**FINAL FINDINGS AND DECISION BY THE DESIGN
COMMISSION RENDERED ON April 7, 2022**

**CASE FILE NUMBER: LU 21-108433 DZ – ARGYLE HOUSING
PC # 20-202695**

Type III Design Review for construction of approximately 290 residential units in an eleven-story building in the Kenton Plan District. The project site includes two parcels totaling 25,000 SF adjacent to the Kenton / North Denver Avenue MAX light rail station. The project includes main entrances along both street frontages, outdoor areas at the ground level and the rooftop, individual balconies, and common spaces through the building. A composite rain screen cladding is proposed above a concrete base with metal storefront systems at the ground level.

EAST ELEVATION

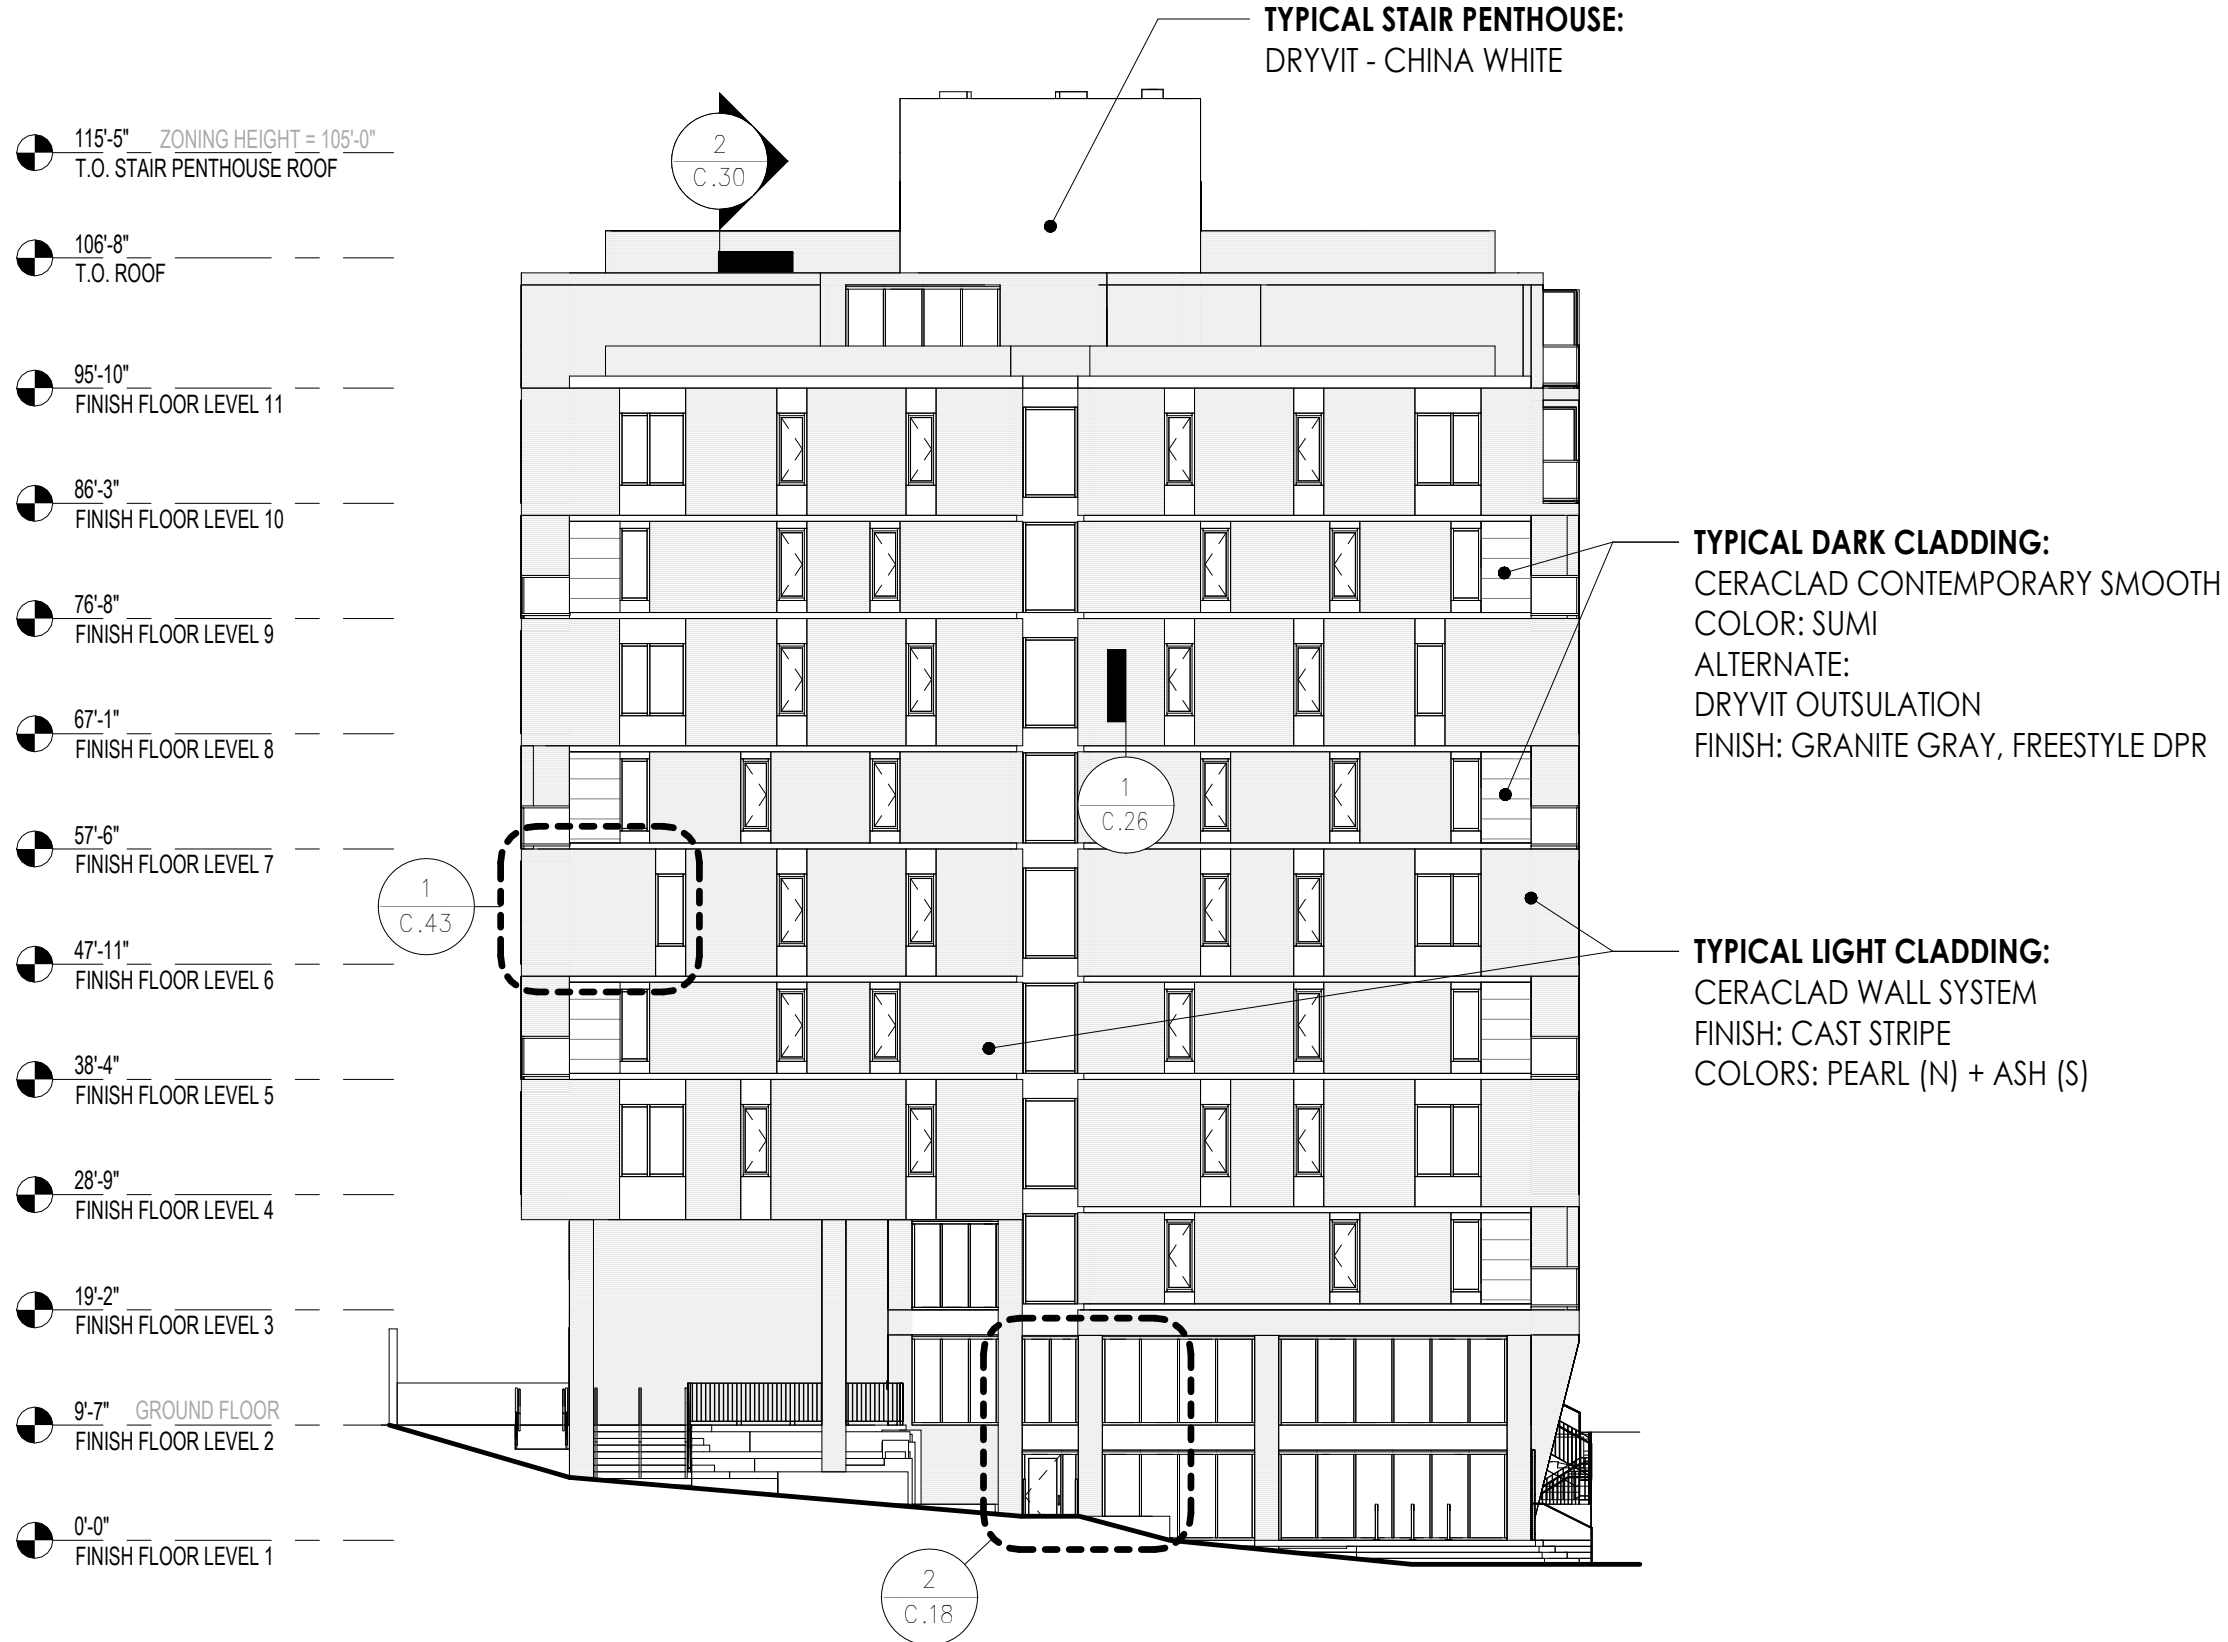
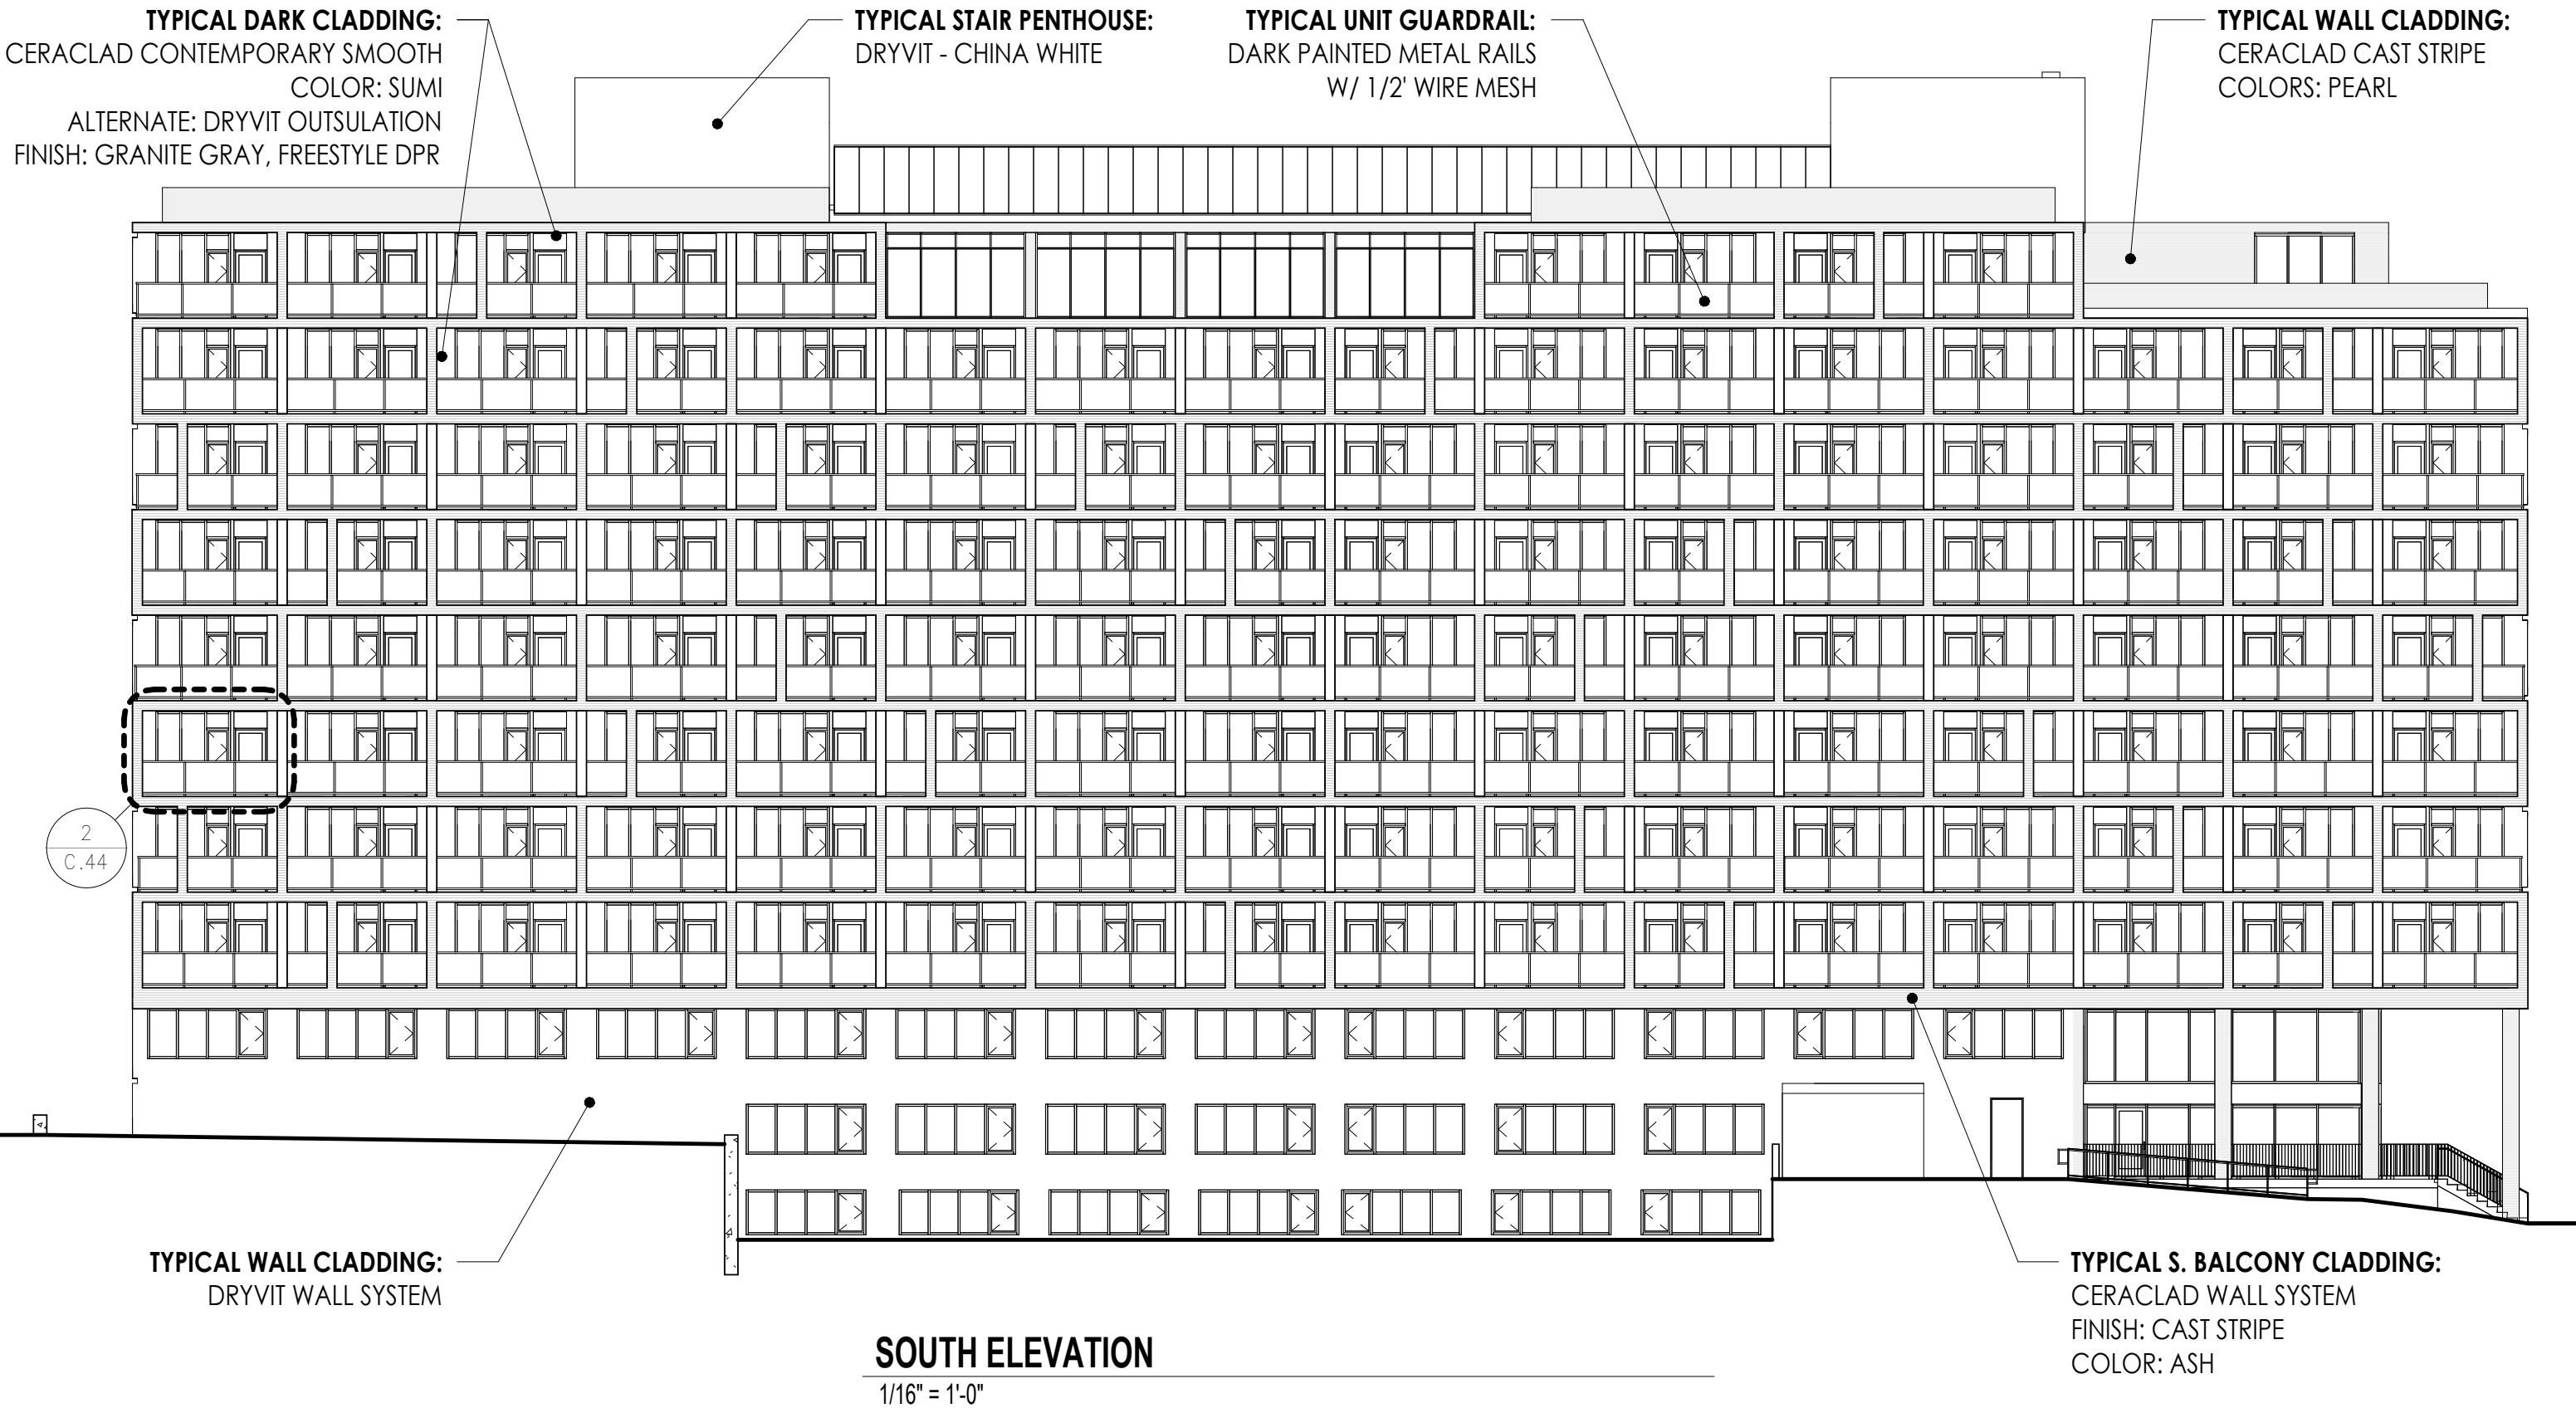
- 4. Cera-clad and Dry-Vit: The Commission was split on Dryvit.**
Response: The primary design (C.60) is still proposed as primarily Ceraclad, with Alternate 1 (C.61) proposed as a VE alternate, with Dryvit only in areas that are recessed within balconies and not at high exposure. Alternate 2 (C.62) has been eliminated. C.8, C.9, C.10, C.11, C.60, C.61, C.62.
